SUBJECT: Renewal of USNRC License No 04-12727-02, Silas B. Hays Army Hospital, Fort Ord, CA

1. This letter is submitted in response to the NRC letter (Control No. 99837) dated 14 March 1980.
2. The basic letter makes reference to specific portions of the application which was submitted for renewal of USNRC License No. 04-12727-02, Silas B. Hays Army Hospital, Fort Ord, CA. Sections of the Application referenced in the basic letter were modified to provide clarity for further consideration for USNRC License renewal. Modified sections of the application are inclosed in the order described in the basic.

3. As requested, the following clarification is submitted specific to each question:
 - a. In view of comments 1 and 2 of the basic letter from the NRC, the present Radiation Protection Officer, does not meet training requirements specified in Appendix A, Items 1a and 1b (Reg Guide 10.8). Another qualified individual's credentials is presented for consideration as radiation protection officer. The license application has been amended accordingly.

FENCES AROUND THE 2 CONTAINERS STORING
RADIOACTIVE MATERIALS.

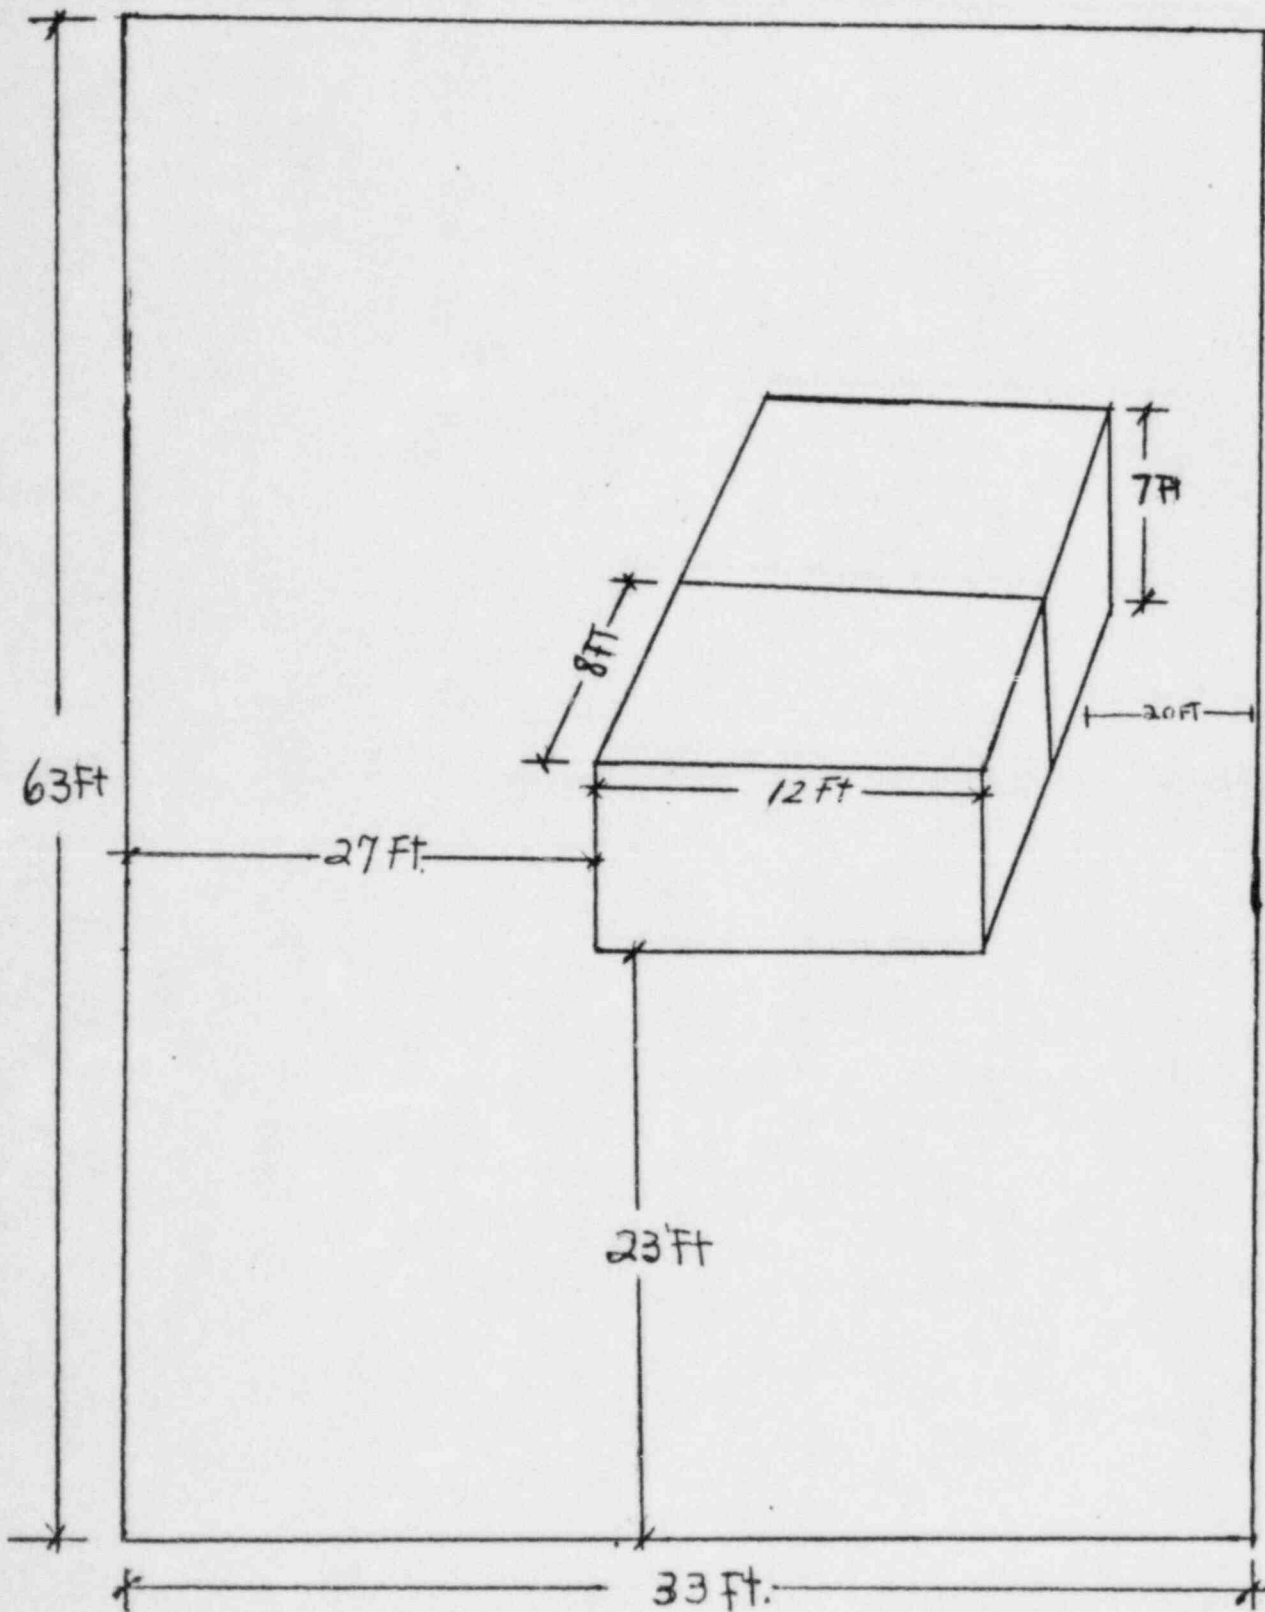
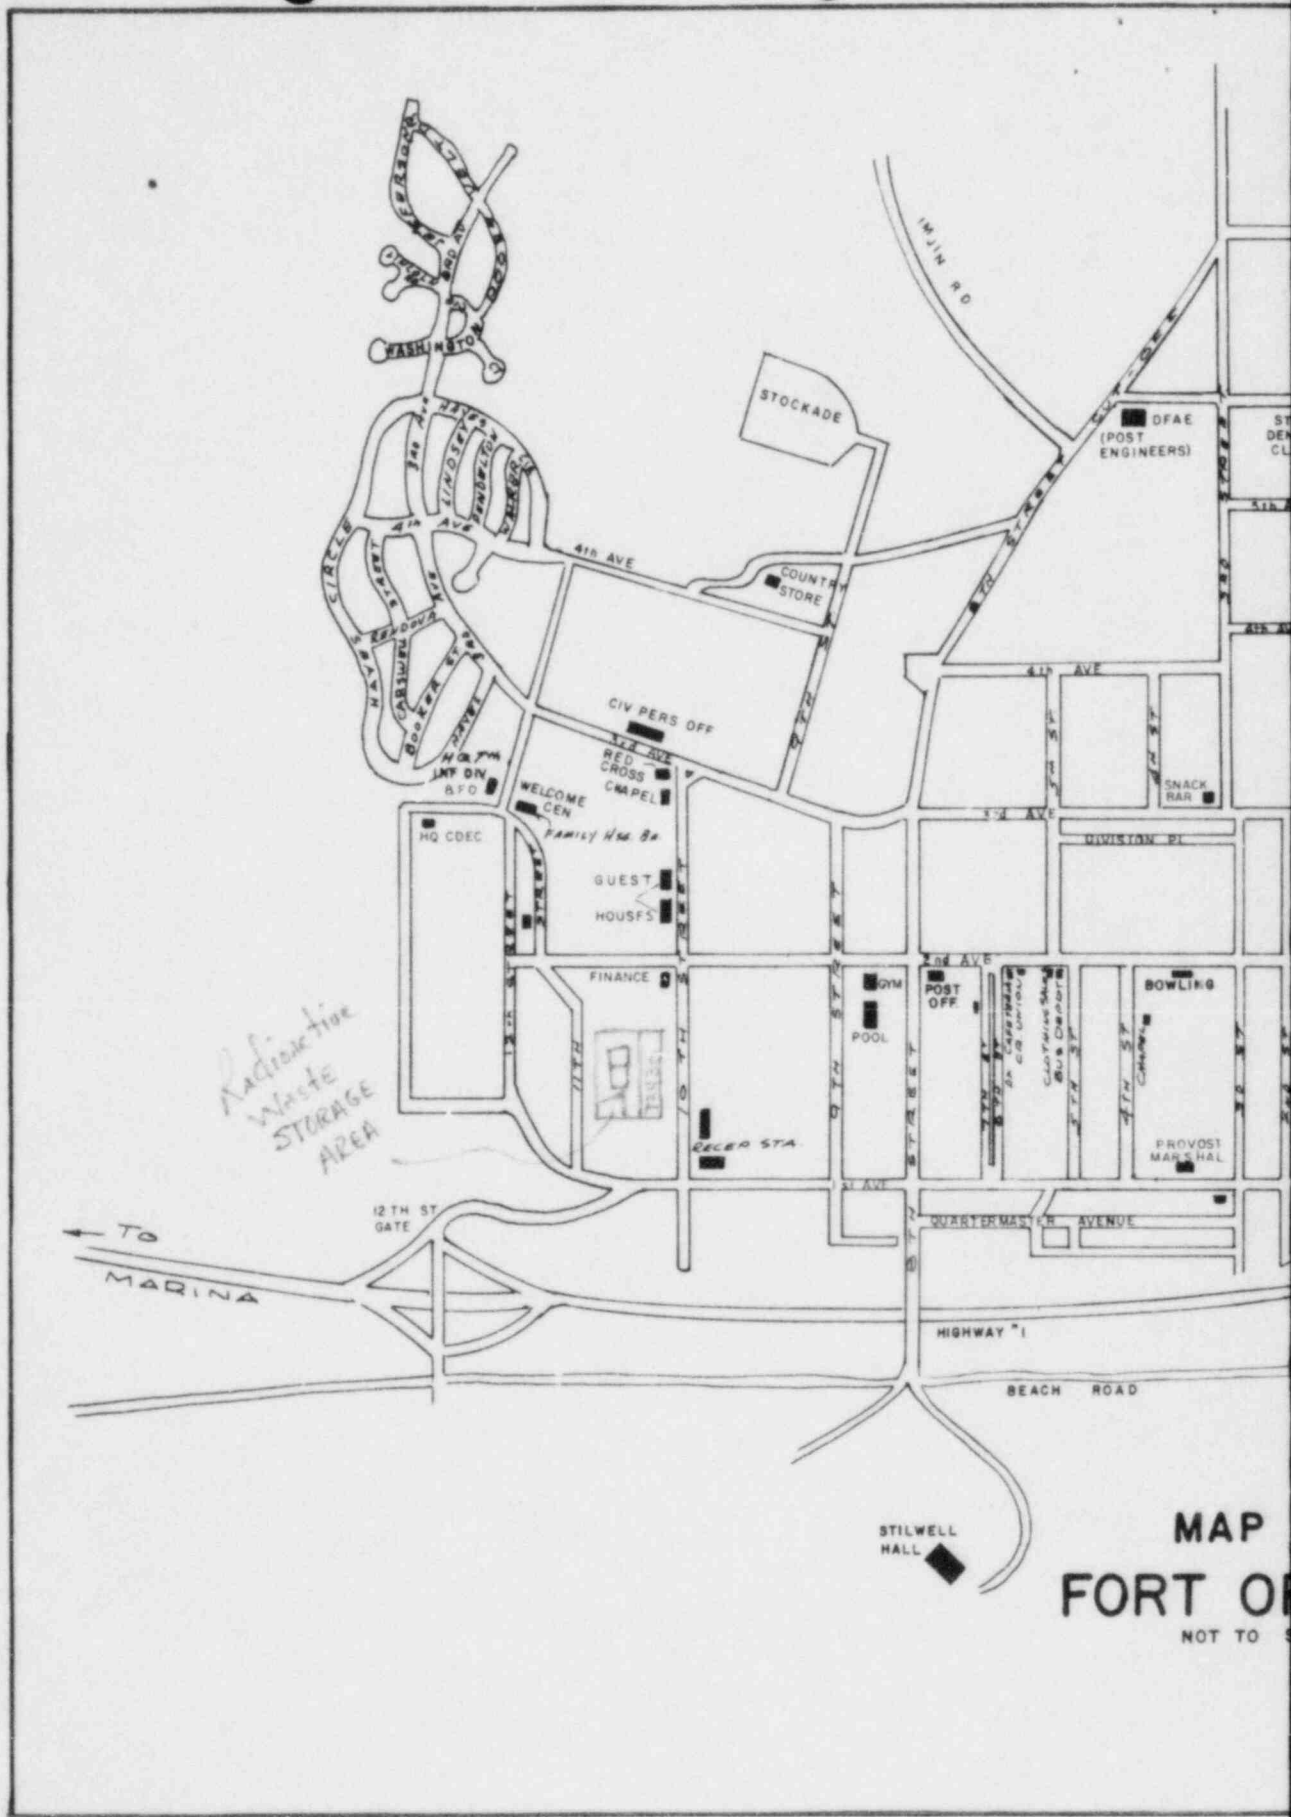
q. Paragraph 7d of Item No. 18 of the license has been modified to include statutory requirements (49 CFR and 10 CFR 20) which are observed in the disposition of radioactive waste. Army Regulation 755-15 entitled "Disposal of Unwanted Radioactive Waste" establishes requirements for administrative, budgetary and intra-agency coordination activities within the Department of the Army. AR 755-15 is provided as Inclosure 11. Paragraph 3c and 11 of AR 755-15 are relevant to the subject license application. This modification is submitted to the NRC for further clarity and consideration. It should be noted that the storage facility described in paragraph 7d, Item No. 18 is under the control of both the radiation protection officer of the licensed facility (USNRC License No. 04-12727-02) and the Fort Ord radiation protection officer who manages the Fort Ord radioactive material disposal facility in accordance with AR 755-15, 10 CFR 20, and 49 CFR. The Fort Ord radiation protection officer has been approved by the Silas B. Hays Radiation Protection Committee as a user of licensed materials in order to provide assistance to the hospital RPO with managing waste materials. This individual's curriculum vitae is submitted as Inclosure 12.

(1) Used TC-99m generators, long-lived radioactive waste materials, high radioactive waste and other solid waste are transported to the radioactive waste storage facility which is described in the diagram and map on the following pages. The waste storage facility consists of two 8ft X 12 ft exportable containers secured by an 8 foot fence surrounding an area 63ft X 33ft. Both containers and the surrounding fence remain locked at all times. The appropriate radiation warning signs are posted on the door of each container and at the fence gate. All materials which are transferred to the facility will be packaged in DOT approved containers prior to transport.

(2) The storage facility described above is managed by the Fort Ord radiation protection officer. However, the facility is under the joint control of both the Fort Ord RPO and the RPO of the licensed facility (USNRC license No. 04-12727-02, Silas B. Hays Army Hospital). The Fort Ord RPO has been approved by the Radiation Protection Committee as a user of the licensed material and to act as an agent on behalf of the license.

(3) Both the Silas B. Hays Army Hospital and the Fort Ord RPO's conduct joint inspections and surveys of the waste storage facility on a weekly basis. It is the sole responsibility of the Silas B. Hays Army Hospital Radiation Protection Officer to ensure that waste generated by the hospital Nuclear Medicine Service are managed in accordance with pertinent NRC and DOT regulations.
